# NSW Department of Planning and Environment – Prior to Commencement of Construction Conditions Picton High School – Traffic Engineering Statement - Response to Condition B34

Stantec has reviewed the car park and access layout for the redevelopment of Picton High School at Argyle Street, Picton against the following documents:

- Application number: SSD 8640
- Address: 480 Argyle Street, Picton
- Proposed development: Picton High School redevelopment

SITE PLAN -PROPOSED MILESTONE 3

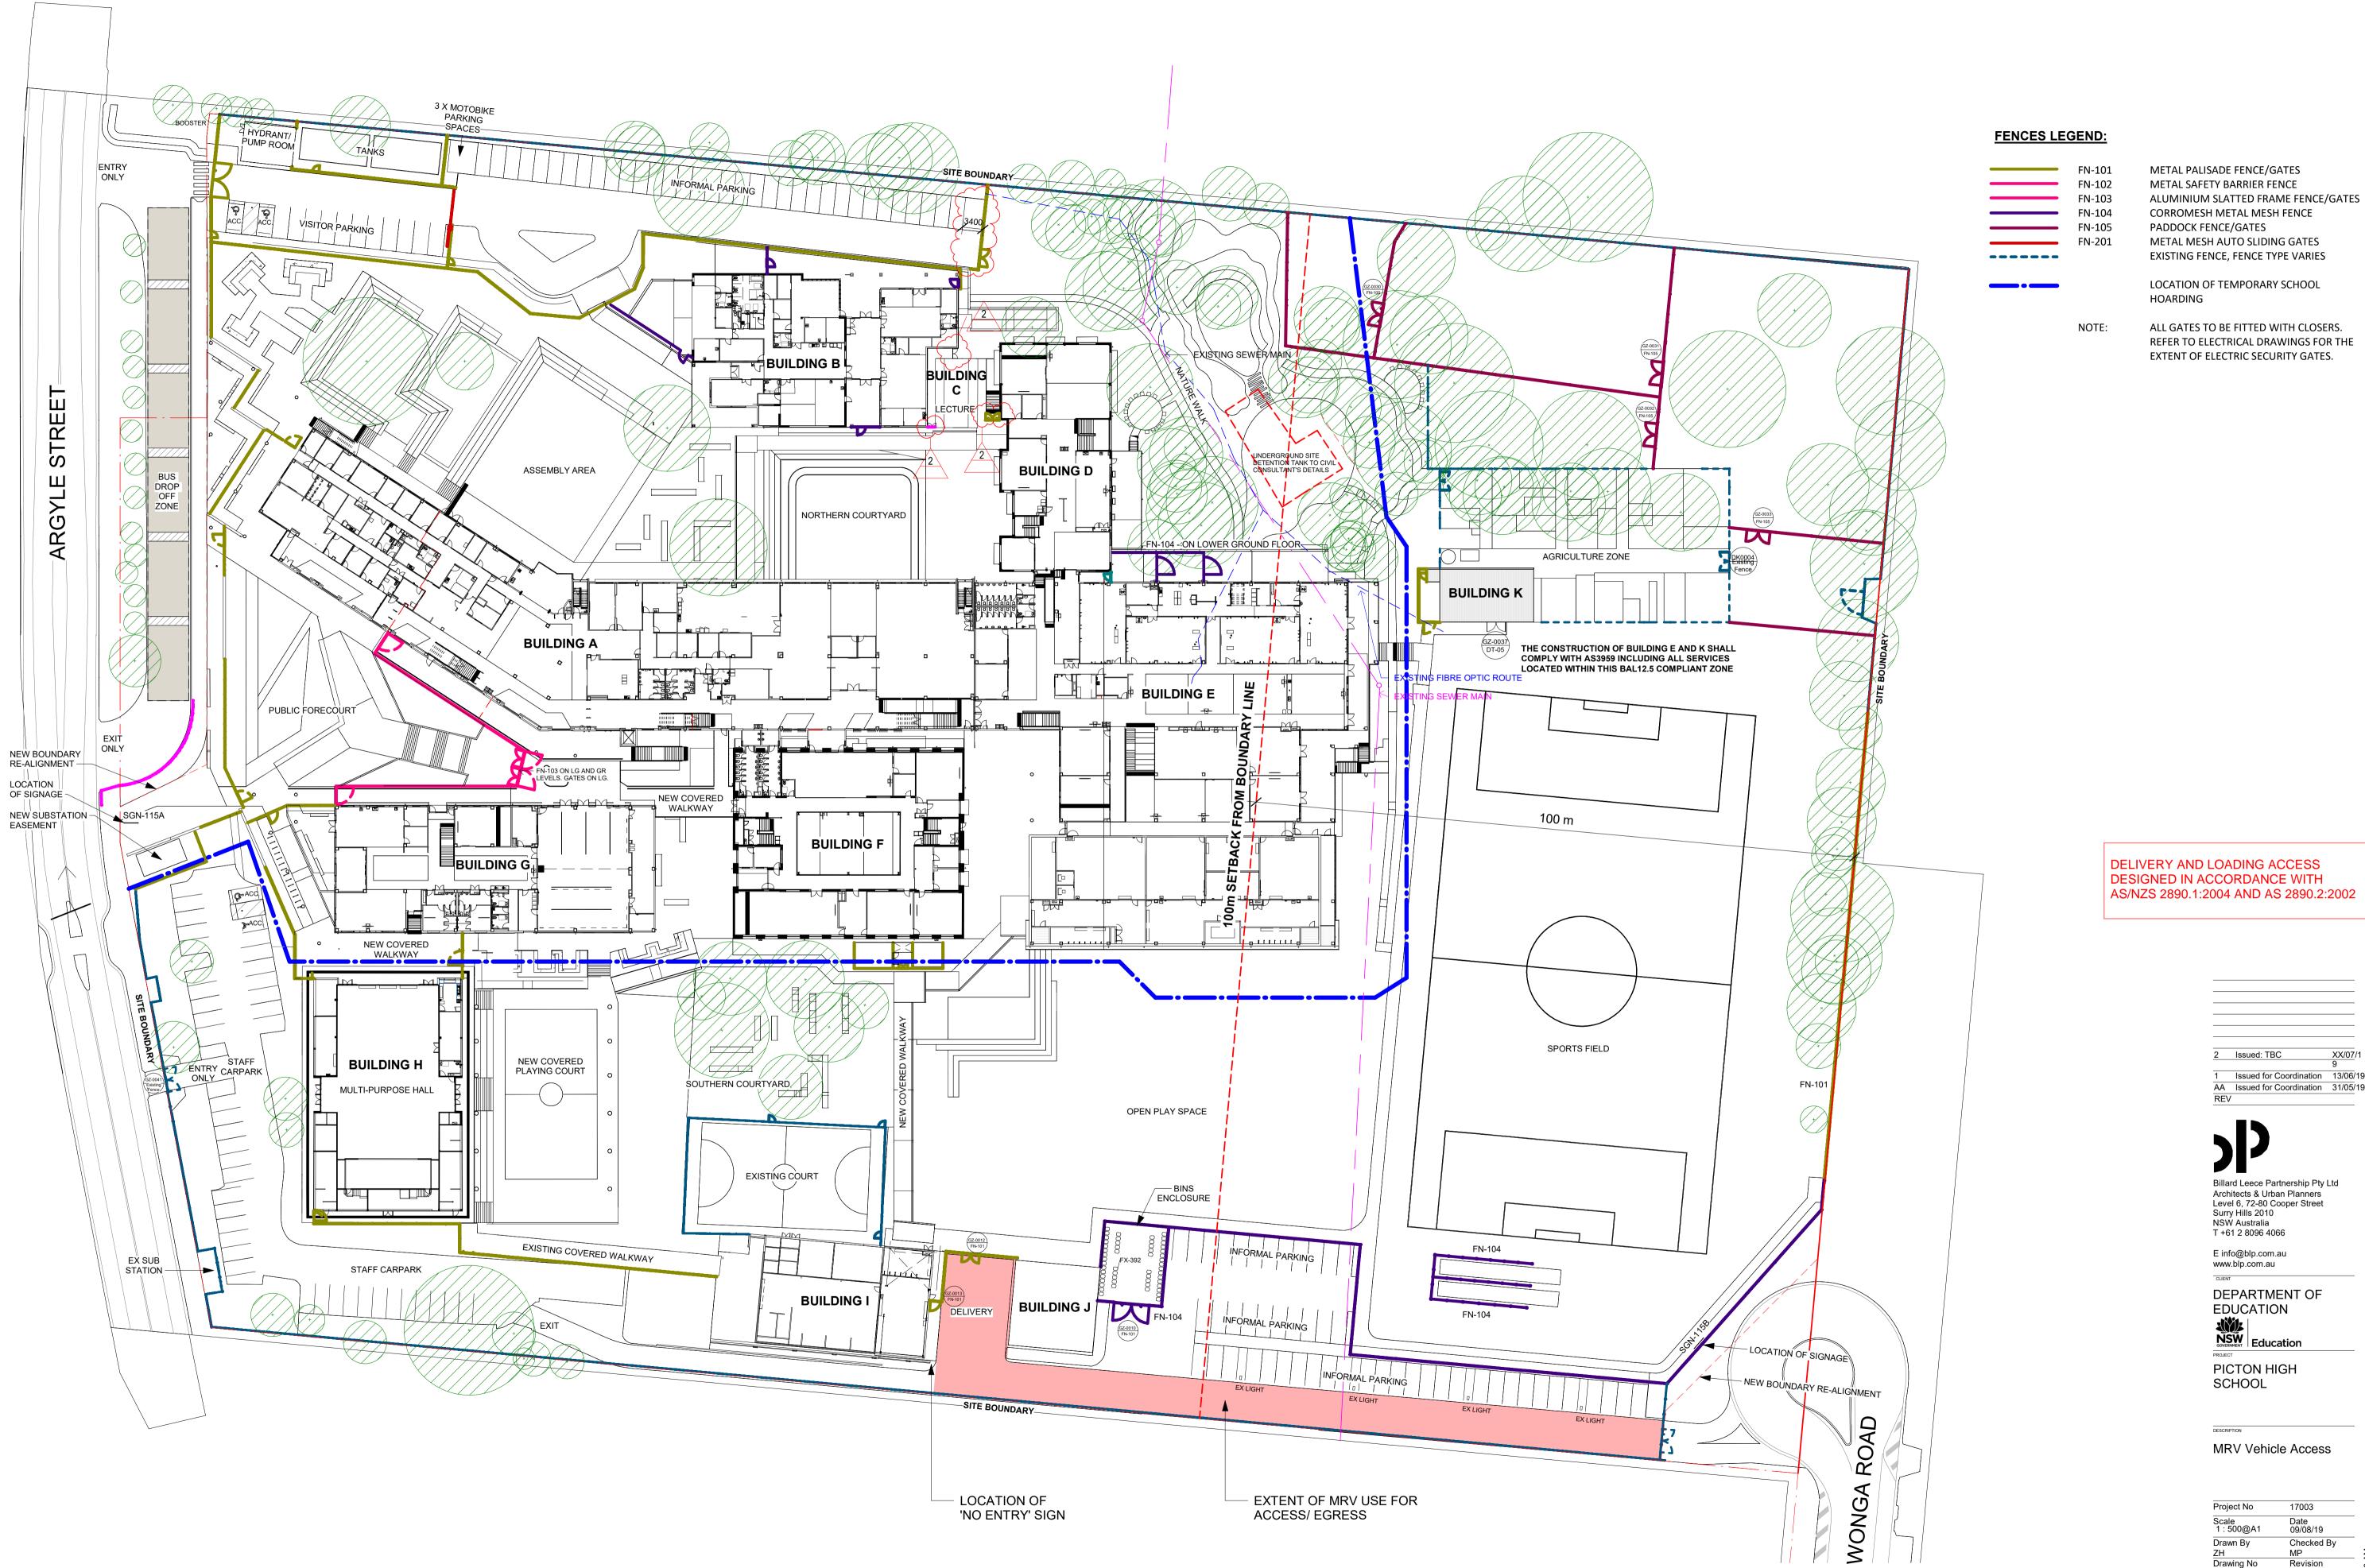
It is proposed to provide 100 new car parking spaces, which have been designed in accordance with AS/NZS 2890.1:2004.

The car park compliance assessment for the existing staff carpark and proposed new car parking spaces within the site is provided in **Table 2**. The last column identifies the compliance of each design element; where compliance with Australian Standards is not achieved, further information is provided below.

Accordingly, it is considered that all car parking spaces have been designed in accordance with AS/NZS 2890.1:2004 and AS/NZS 2890.6:2009, and that the minimum requirement of 141 car parking spaces including four accessible spaces will be provided on-site.

Room Layout Sheet STAFF CARPARK MODIFICATIONS
LB00/tilloit

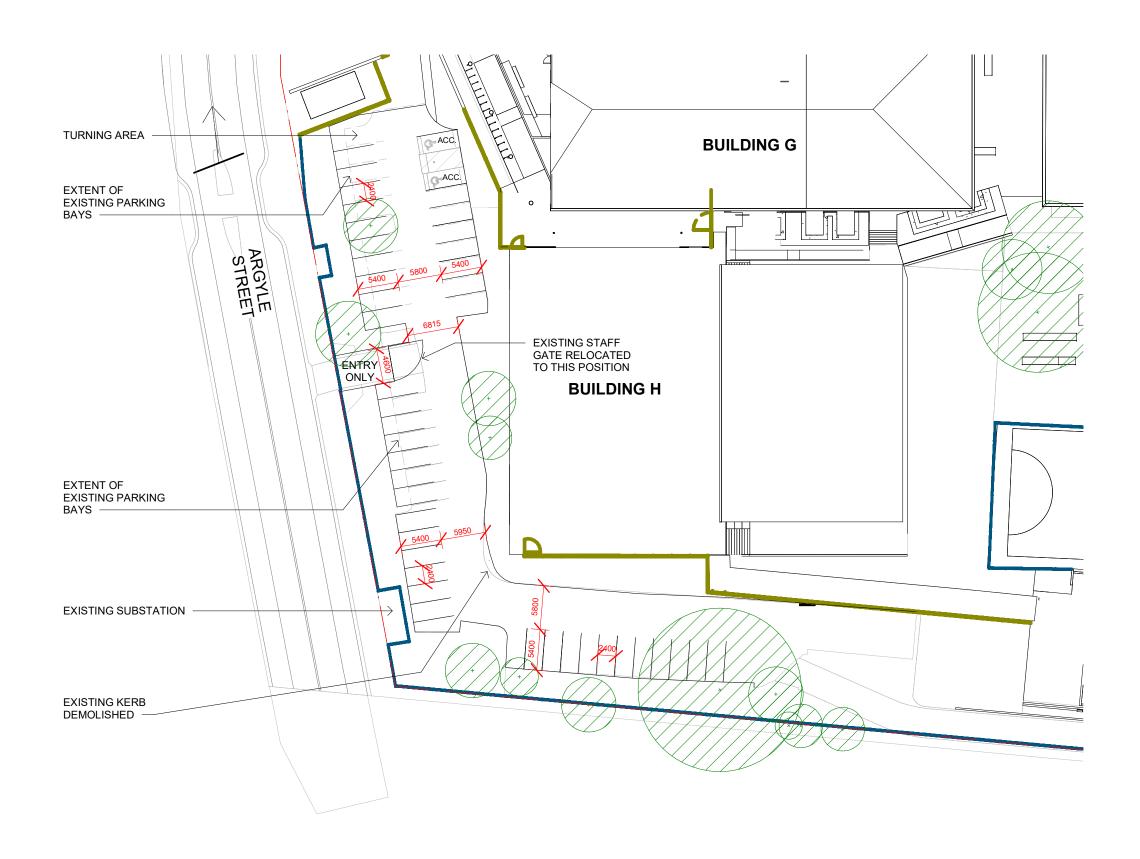
42 existing car parking spaces within the staff car park are proposed to be retained. It is noted that the staff car park has been modified to comply with the AS/NZ 2890.1:2004 and AS/NZS 2890.6:2009. The modified plan is prepared by BLP and has been attached within sheet no.3 of Appendix A.

A turning bay is proposed to be provided along the western boundary of the staff carpark, to allow a B99 vehicle perform a three-point turn manoeuvrer, in the event that the car park is fully occupied. This is shown within drawing sheet no.3 of Appendix B.

Drawing SK-01 (prepared by BLP) shows the access and loading area relative to the rest of the site, and notes that the delivery and loading facilities have been designed in accordance with both AS/NZS 2890.1:2004 and AS 2890.2:2002. The access has a minimum access / aisle width of 6.8 metres, allowing for simultaneous two-way vehicle movement.
